**PUBLIC INTEREST REVIEW FOR GROUNDWATER APPLICATIONS**

TO: Water Rights Section Date 05/11/2016  
 FROM: Groundwater Section Phillip I. Marcy  
 SUBJECT: Application G- 18201 Reviewer's Name  
 Supersedes review of \_\_\_\_\_ Date of Review(s) \_\_\_\_\_

**A. GENERAL INFORMATION:** Applicant's Name: Ben McCune County: Clackamas

A1. Applicant(s) seek(s) 0.41 cfs from 2 well(s) in the Willamette Basin,  
Beaver Creek subbasin

Water-Level Trends in Nearby Wells

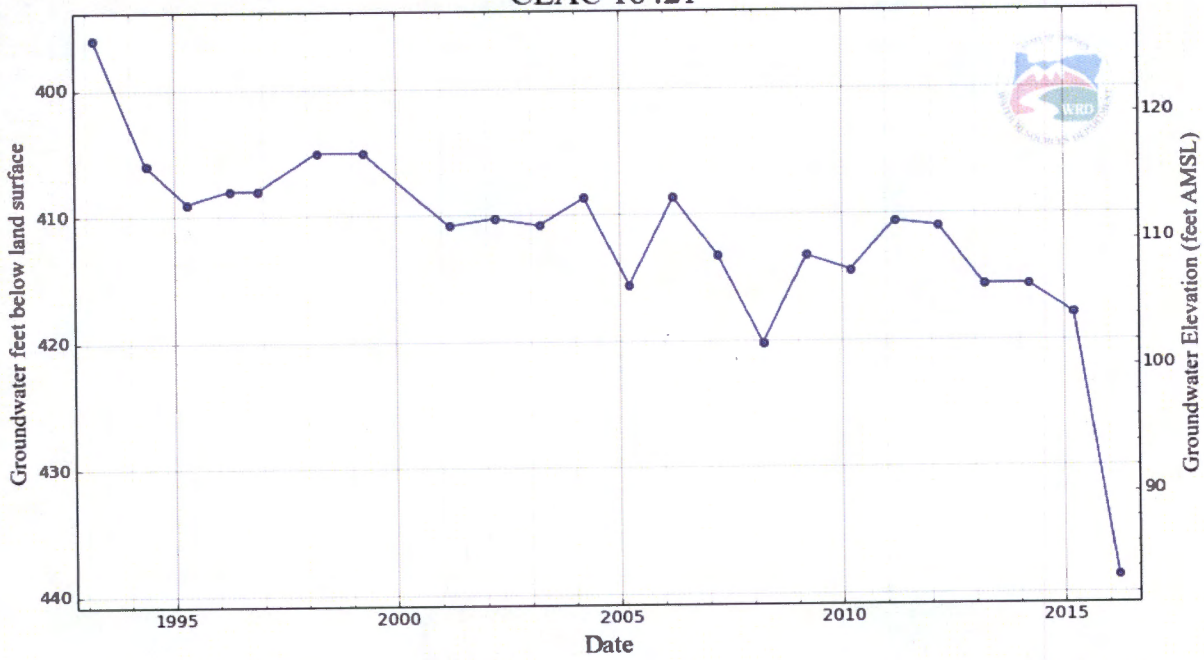
Water levels within nearby CRBG wells (see attached hydrographs) have been historically stable until the past two years. Recent observed declines are likely the result of increased pumping of groundwater during the past year, brought on by drought conditions in the Willamette basin in 2015. If groundwater declines continue, however, priority will be given to senior right holders in the area, leading to possible curtailment or discontinuation of pumping if decline triggers within condition 7N are reached.
